Errata

J. H. Waddell, "Design of rotating prisms for high-speed cameras, *Jour. SMPE*, vol. 53, pp. 496-501, Nov. 1949.

Reply to the Letter Above

Page 498: For Fig. 2, substitute the figure shown on p. 83.

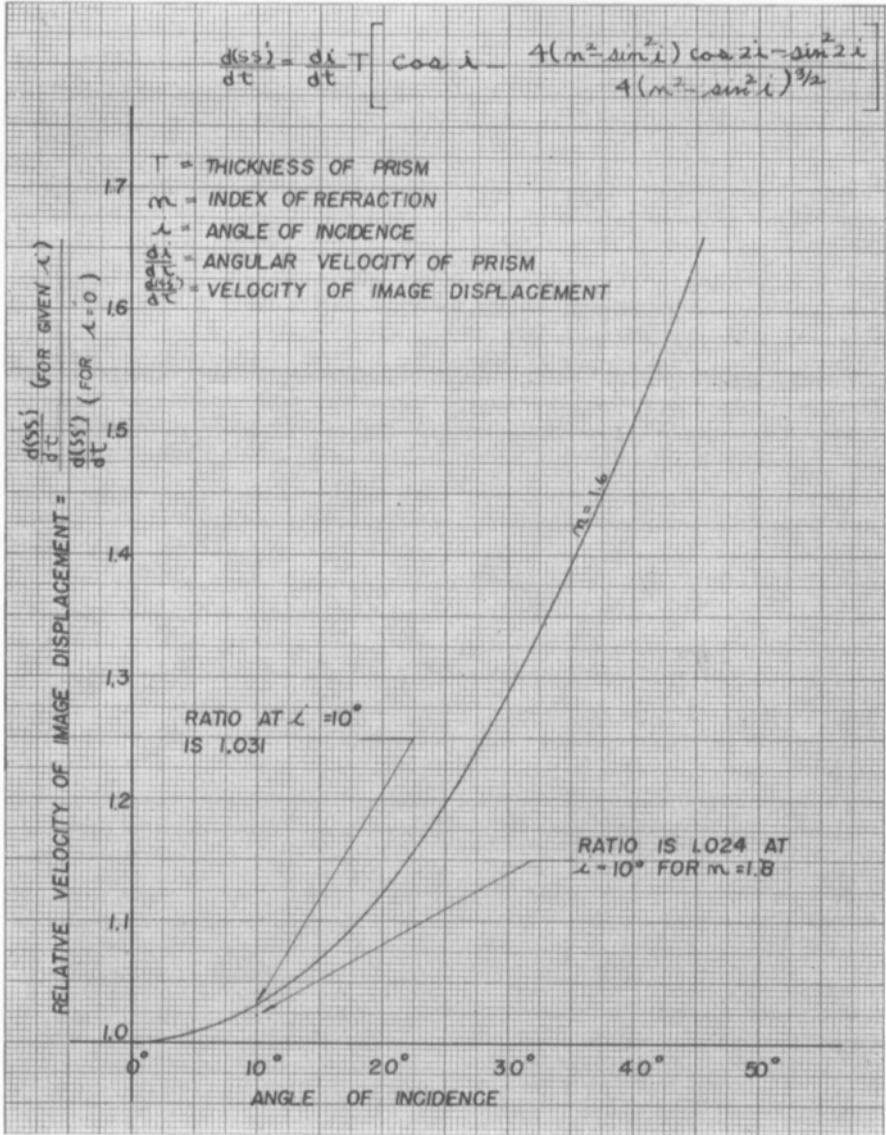
There was, as has been turned over to the Society, a typographical error in Formula 5 in the paper, *Design of Rotating Prisms for High Speed Cameras* by John H. Waddell, and consequently in the calculations that illustrated Fig. 2 positive values are shown rather than negative values as the relative velocity. However, quoting from a letter from one of my former associates, it is to be pointed out that this does not affect the validity of thinking in the design of rotating prisms in the least.
